TOWN OF ST. MICHAELS  
SKETCH SITE PLAN REVIEW APPLICATION  
(SEE §110-2B of the Code of the Town of St. Michaels)

- (1) PROPERTY OWNER: CBMM BUSINESS OWNER: CBMM  
MAILING ADDRESS: 213 North Talbot St, St. Michaels, MD 21663  
TELEPHONE #: 410-745-4951
- (2) PROJECT NAME: Multipurpose Building

STAFF REPORT PREPARED BY: Kymberly Kudla, Zoning Officer  
DATE OF SKETCH REPORT PREPARATION: June 4, 2021  
DATE OF SKETCH PLAN REVIEW: June 15, 2021

REVIEW: Sketch plan review (step 1/3)

FLOOR PLANS

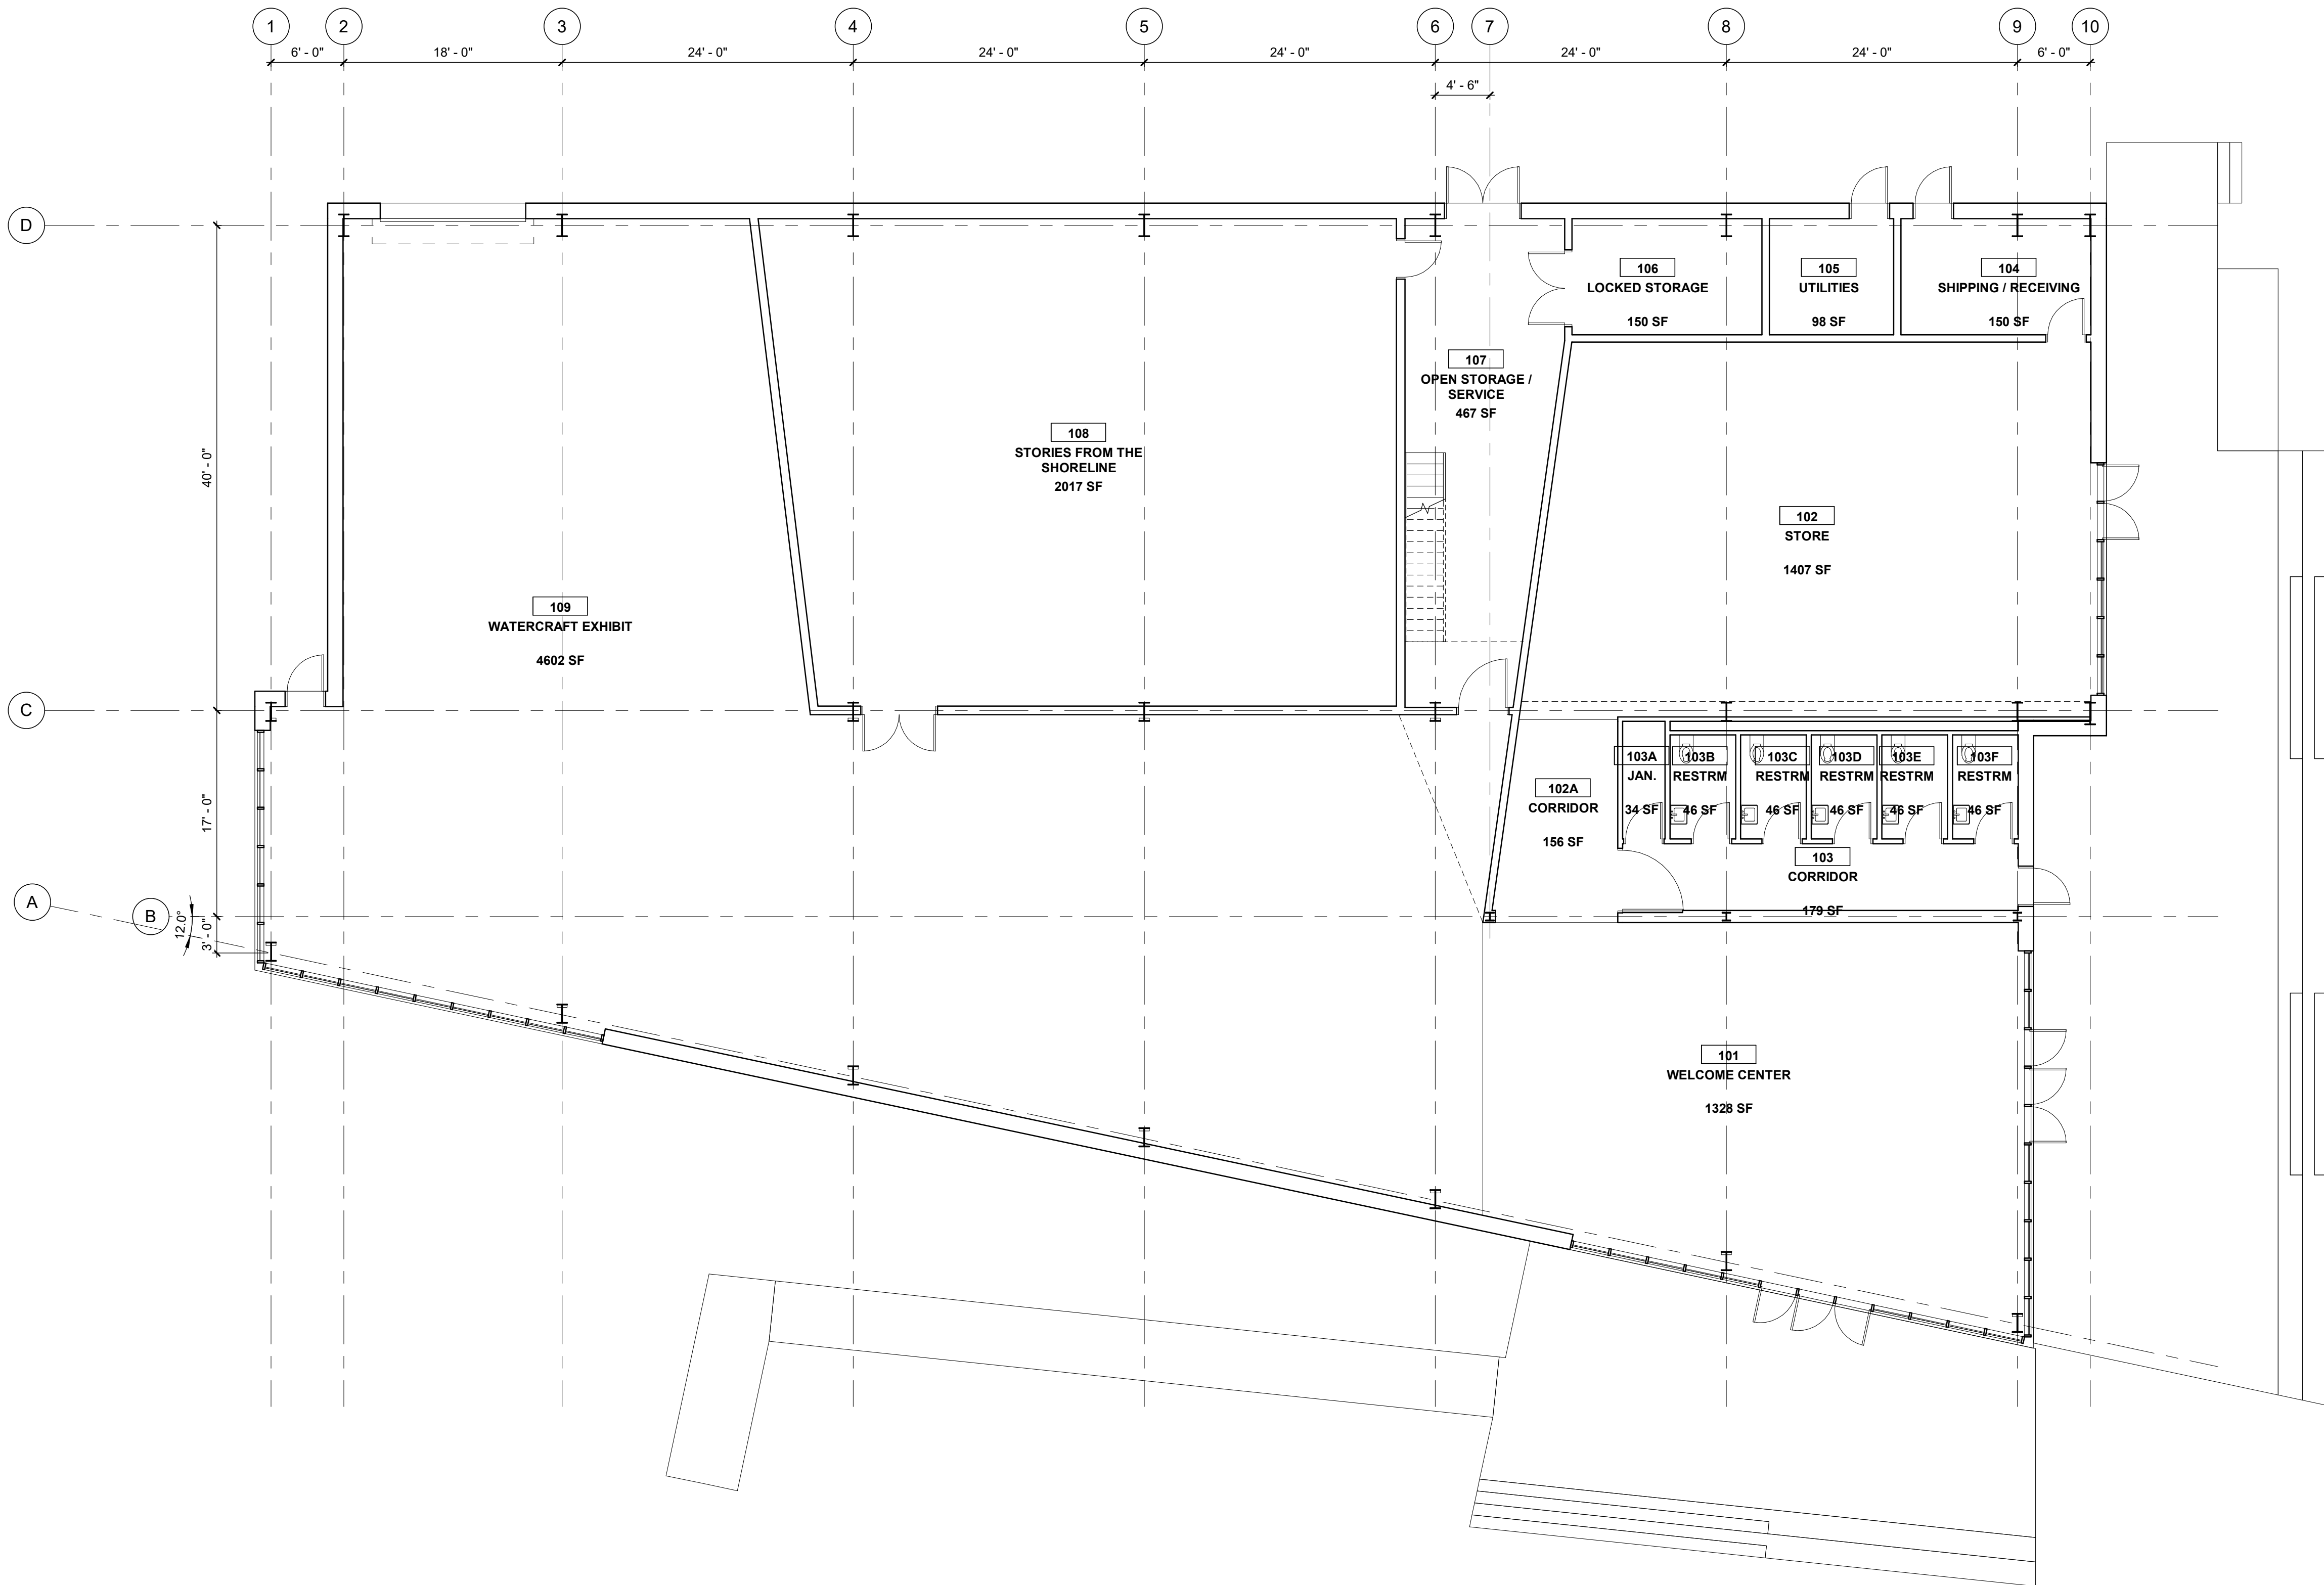
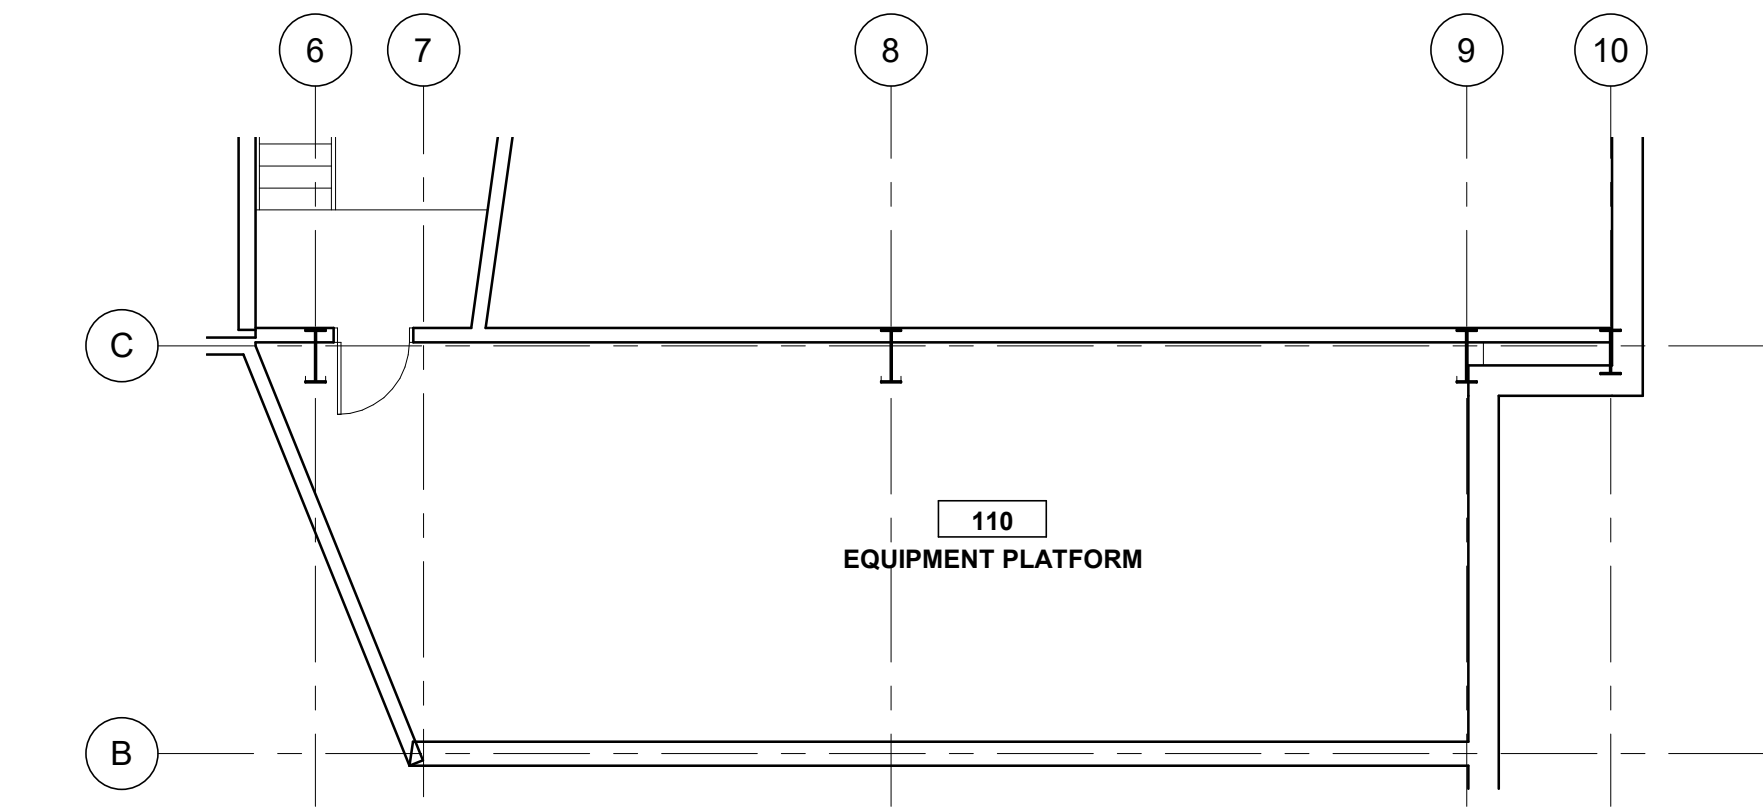
5. Except as provided for by Subsection A(6), (11) and (12), sale of any article fabricated in or brought to a museum shall be made only through an indoor gift shop, outdoor booths, or the museum's visitors center. The maximum area of a museum devoted to the sale of goods (including display area, aisles, storage, and cashier area) in a museum shall not exceed 2,500 square feet. – ***Proposed store is 1,407 SF.***

12. Sale of food and drinks for the enjoyment and convenience of visitors to a museum, other than as permitted by Subsection A(6) above, provided that all food is pre-packaged (i.e., not cooked/prepared on site) and the space for the sale of food and drinks does not exceed 600 square feet which area is included in the square footage permitted in Subsection A(5) above. – ***Will the sale of food be moved to new location? Need to know if remaining in current location the square footage of that space.***
